Order-No.: DD+DIS119.00E

Field Service Bulletin Nr. 9 for ADC Solo Type 5155

Suction cups don't release IP

Figure 1

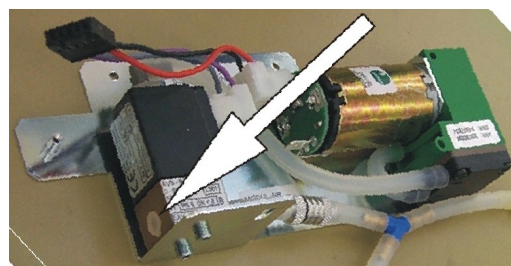
Transportation of Image Plate (IP) does not work properly. The IP remains at the suction cups because there is not sufficient air flow to resolve the vacuum.

Dust protection of solenoid valve has not been removed.

3. If the dust protection (arrow) is still on the solenoid valve, use a firm solid tool (e.g. screwdriver) to remove the plastic plug from the solenoid valve of the vacuum pump.

Remove dust protection.

The dust protection can be removed permanently. It is not needed during operation.
